DELEGATED DECISIONS BY CABINET MEMBER FOR TRANSPORT

OXFORD: A4158 ROSE HILL – OPTIONS FOR SAFETY IMPROVEMENTS AT THE SERVICE ROAD JUNCTIONS

Report by Director of Environment and Highways

Option 5 – prohibition of vehicles by camera enforcement within service road

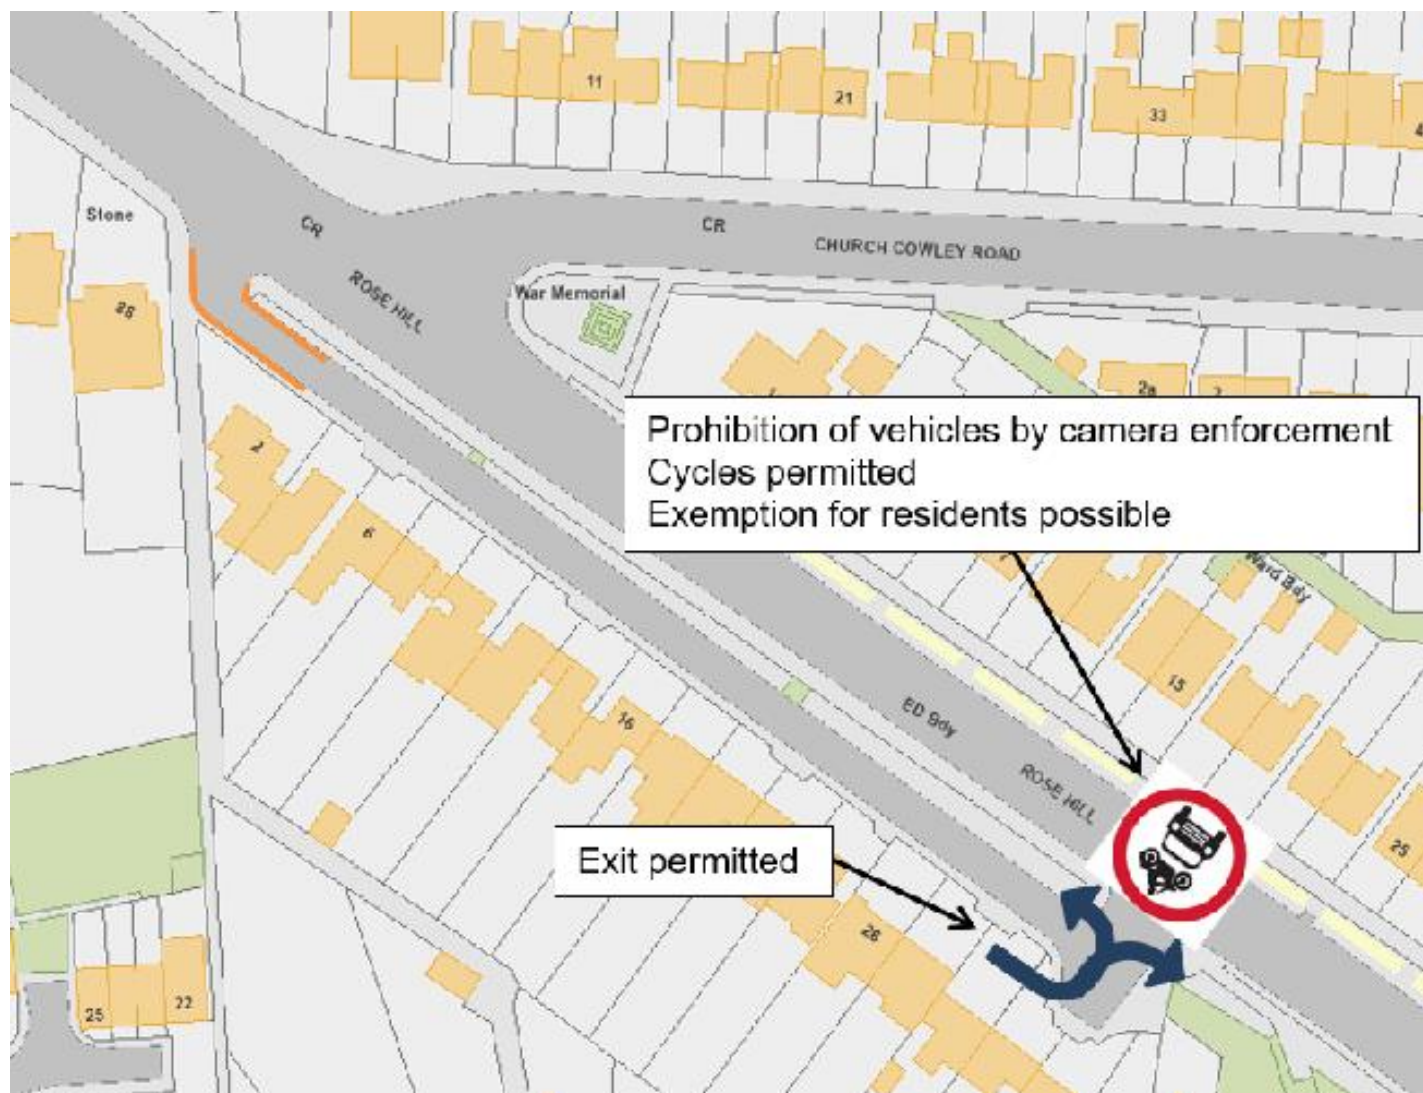
62. This option is as illustrated in **Annex 6**. Entry to the service road for all vehicles is by either access, while non-exempt vehicles are prohibited from passing northbound through a point somewhere within the service road.

63. The optimum location along the road will have to be determined by further investigation as it will impact several issues. For example, if it were placed at the extreme north end, then all visitors (including to the dental surgery) would be able to enter via the southern end, but would have to turn 180 degrees to exit. Conversely, nearly all visitors would have to enter via the northern end if the restriction were to be placed at the south.

64. It is envisaged that the likely preferred location will be towards the southern end as this will be more visible to drivers, will be easier to sign clearly and will allow vehicles to reverse a short distance to the turning area if they should enter the service road in error.

89. The majority of residents' views offer support for a northbound prohibition of vehicles restriction somewhere along the service road (Option 5). Provided that exemptions are made available to residents, this Option will prevent any vehicles from bypassing the signals (and, therefore, eliminating the manoeuvre that has led to the collisions) while causing negligible impact to the residents themselves.

In consideration of the proposals, Option 5 most closely matches our comments to the council in the previous consultations. However, it is with some concern that if ANPR cameras were introduced to enforce the ban that residents may not be included. This creates a scenario that it would be better that no option be introduced in our opinion. A better solution may be the clever use of two ANPR cameras at either end of the street, so that any cars that go through both camera within say two minutes, are using the street for non-residential or non-delivery purposes. A concern with ANPR, is that taxis and delivery vans are often exempted from these cameras. These are some of the worse offenders at using the service road as a high speed short cut to avoid traffic lights and congestion, so any system that does not include these vehicles, may have limited benefit as a deterrent. Additionally, it has been noted I am sure that entrance from the Northern end of the road is quite awkward and potentially dangerous having to do such a sharp turn left when heading from the south or trying to enter from the Church Cowley Rd. It will be absolutely necessary to have double red lines to completely cover that entrance area and around the dental practice where cars often double stack with the limited parking there. Otherwise there will be insufficient turning circle to enter from the northern end.

90. In conclusion, officers recommend that a prohibition of motor vehicles restriction, at a location to be determined in the service road, is implemented. This would be enforced by signs only initially, with exemptions for residents, although ANPR enforcement could be introduced at a later date if required to improve compliance. It is also recommended that this scheme be initially implemented using an Experimental Traffic Regulation Order so as to facilitate any modifications that may be required following monitoring and evaluation of its operation.

Option 6 – prohibition of vehicles by camera enforcement at southern end

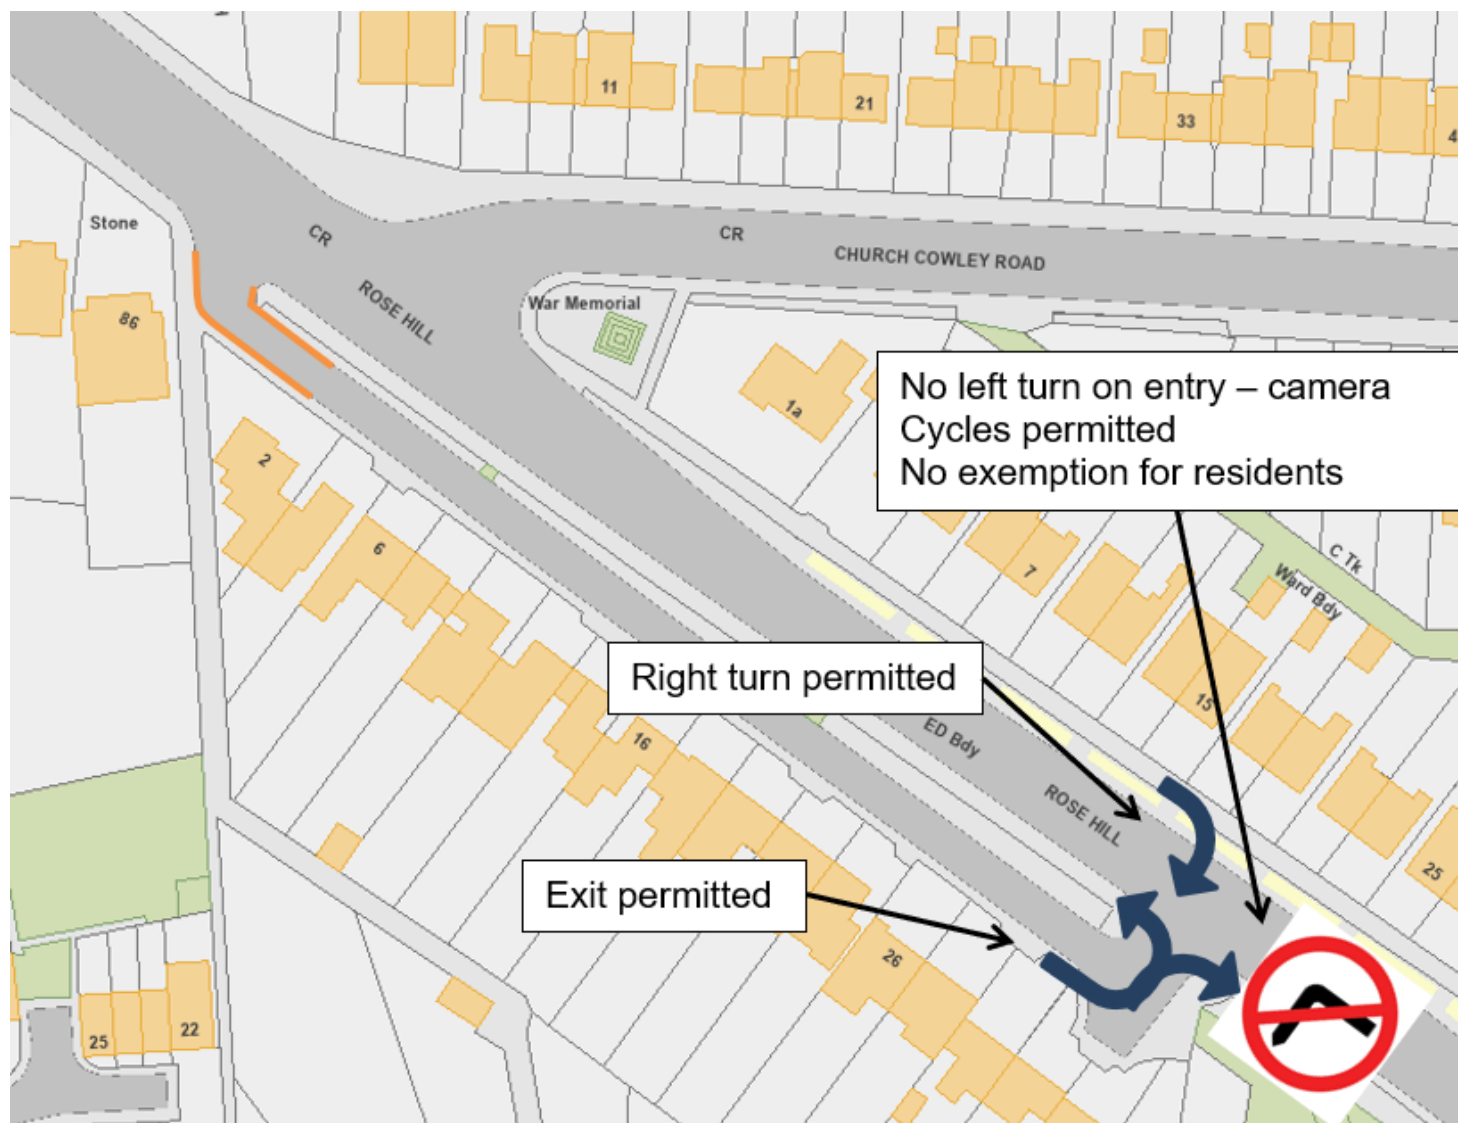
65. This option is as illustrated in **Annex 7**. Exit from the service road for all vehicles is by either access, while non-exempt vehicles are prohibited from entering via the southern end.
66. Signage in advance of, and at the access into the service road will be clear, reducing the number of drivers entering in error.
67. The restriction would mean that any visitors who are approaching from the south along Rose Hill or along Church Cowley Road will be obliged to use the northern access to turn left into the service road. Similarly, visitors approaching from the north will have to make the awkward right turn into the northern access. Residents with permits will retain the option of which access to use.

Option 6 - I think it would be difficult for larger vehicles to potentially enter but could support this.

Option 7 – left turn ban at southern junction

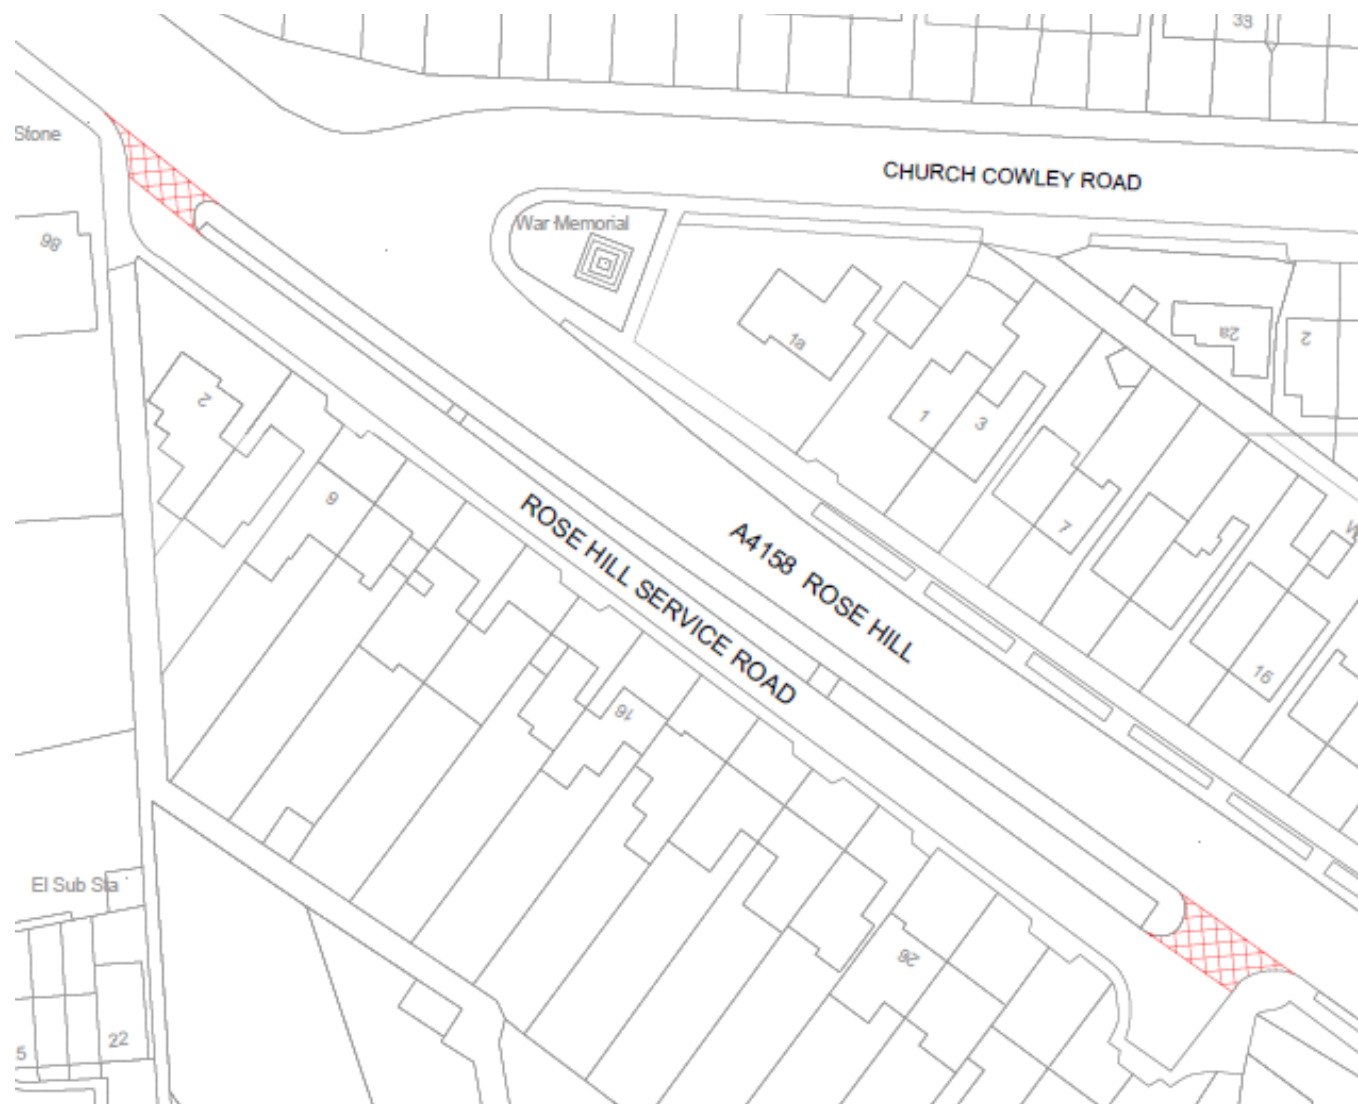
68. This option would have a TRO or ETRO to prohibit vehicles from turning left into the southern access, being enforced by camera(s), as illustrated in **Annex 8**. An additional camera may be required to ensure a distinction between left and right turns in.
69. Signage in advance of, and at the access into the service road will be clear, reducing the number of drivers entering in error.
70. As this option is for a banned turn (as opposed to a prohibition of motor vehicles), no exemptions are allowed other than for emergency vehicles and cycles. Therefore, residents would have to use the northern access when approaching from the south and turning left in.

71. The number of motor vehicles turning left into the southern access will be reduced to zero, although drivers will still be able to turn right in. This may lead to some slight confusion for pedestrians.

Option 8 – Side Road Entry Treatments at both ends

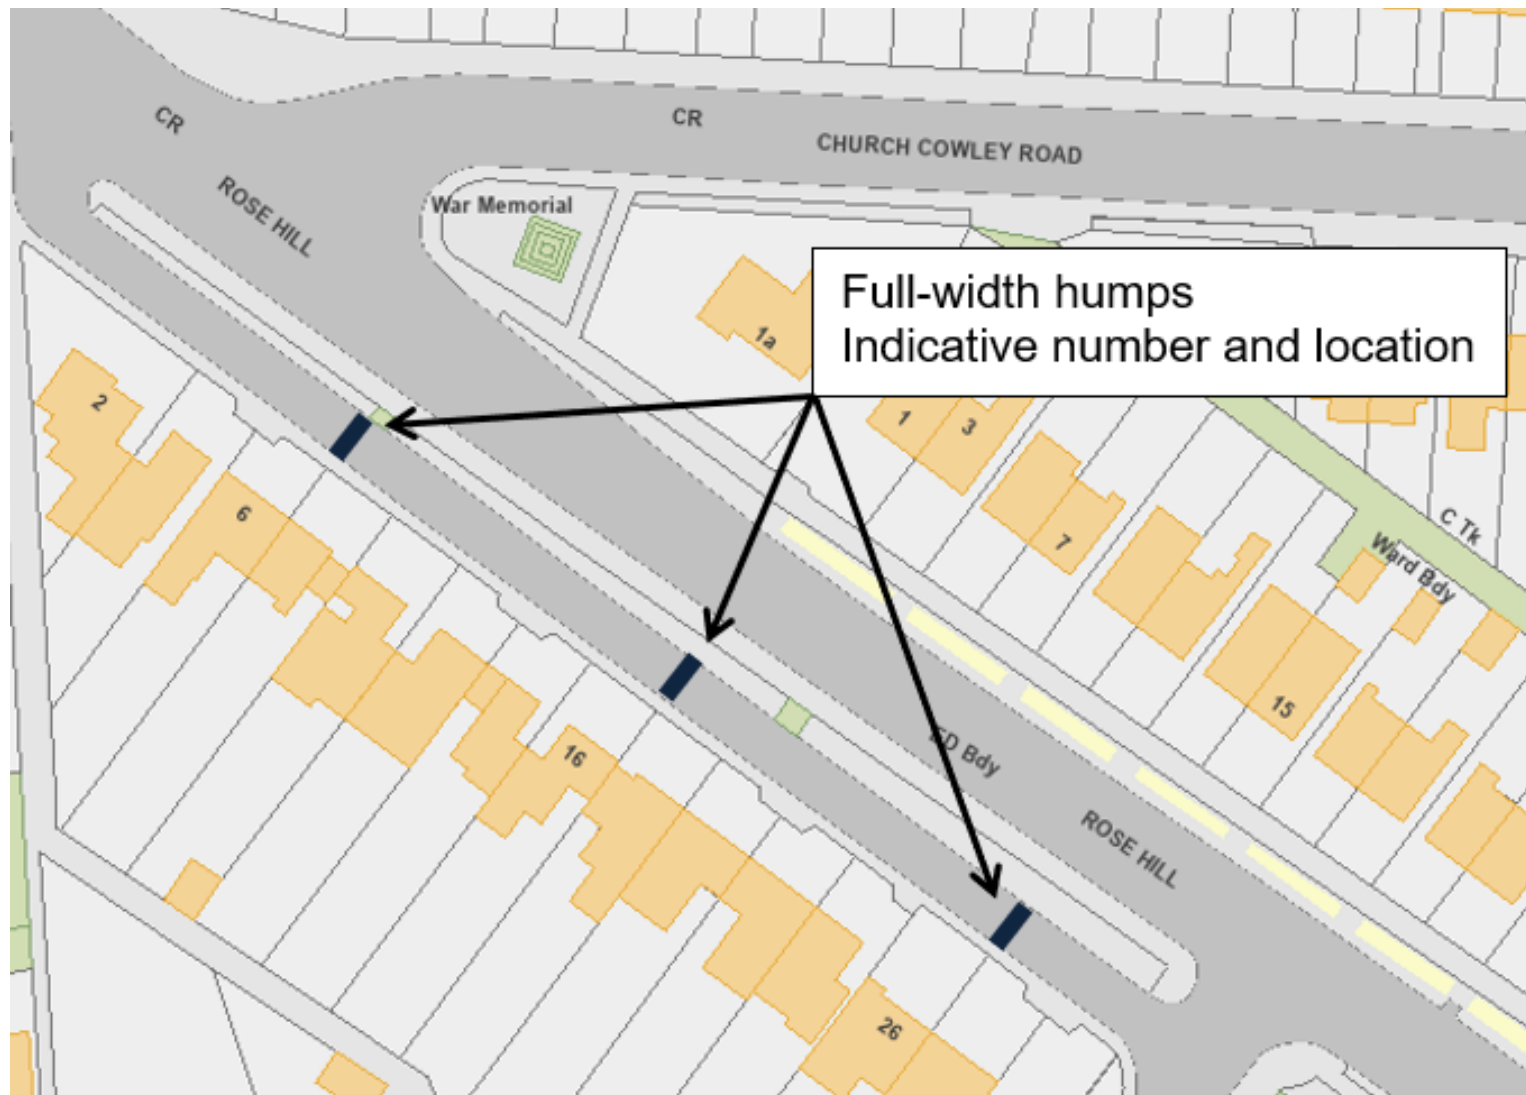
72. The intention of SRETs is to make this route (via the service road) significantly less attractive to northbound traffic as a way of bypassing the signals, without seriously inconveniencing local residents (see **Annex 9**). Those that continue to make the turn will do so at a slower speed, reducing the likelihood and severity of further collisions.
73. Although they cannot be avoided, the SRETs will not prevent vehicles from making a left turn into the southern access and so the collision problem may persist.
74. Unlike the other options above, SRETs will retain all movements at both accesses, thus maintaining full accessibility for the residents. They will also facilitate a safer environment for pedestrians by emphasising priority at the junctions.
75. This option would be relatively expensive to design and construct.

Option 9 – speed humps

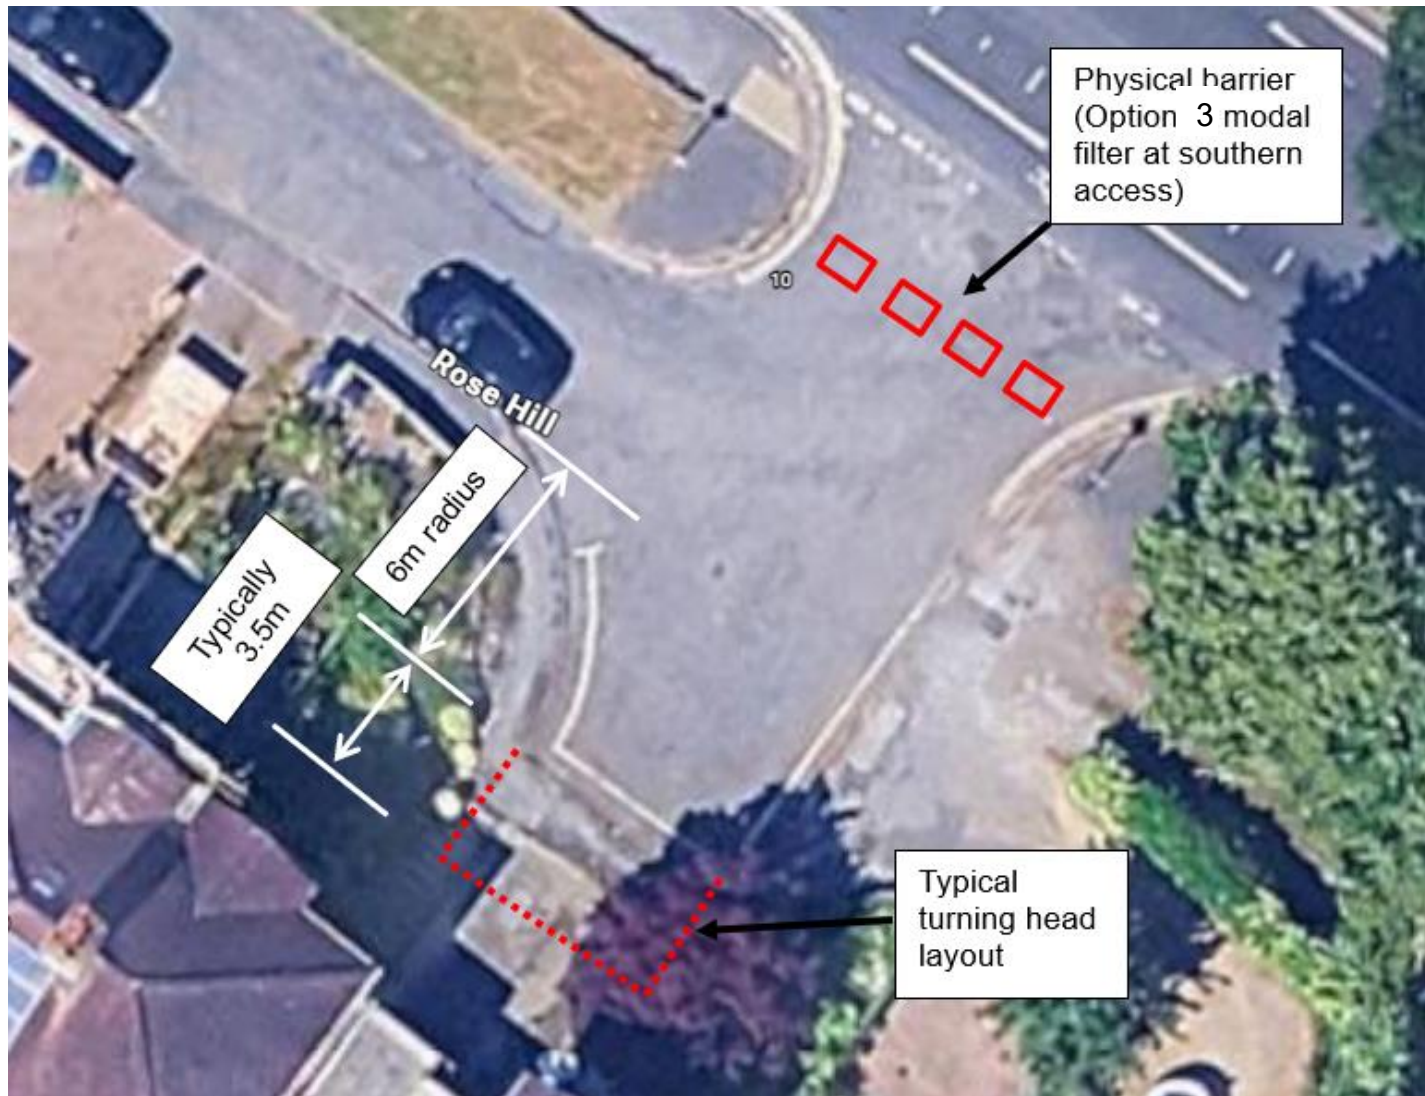
76. Speed humps in the service road would have a similar effect as the SRETs, i.e. to make the route significantly less attractive to northbound traffic as a way of bypassing the signals (see **Annex 10**).

77. The humps on their own would not compel drivers to enter the service road at a slower speed; it will just reduce the number of vehicles doing so. For greater impact, they could be used in conjunction with SRETs or an access only restriction.

78. It is possible that humps would necessitate additional street lighting, depending on the existing levels of illumination. If this option is pursued, it is recommended that a 20mph Zone is introduced in the service road to avoid the need for providing additional street lighting. They would need to be at, or close to, the maximum permitted dimensions as specified in the Road Hump Regulations to provide an effective deterrent.

79. Surveyed mean speeds on the service road are not high – approximately 14mph northbound and 10mph southbound. The purpose of the humps would not explicitly be to reduce speeds further, but to make the route “uncomfortable” and unappealing.
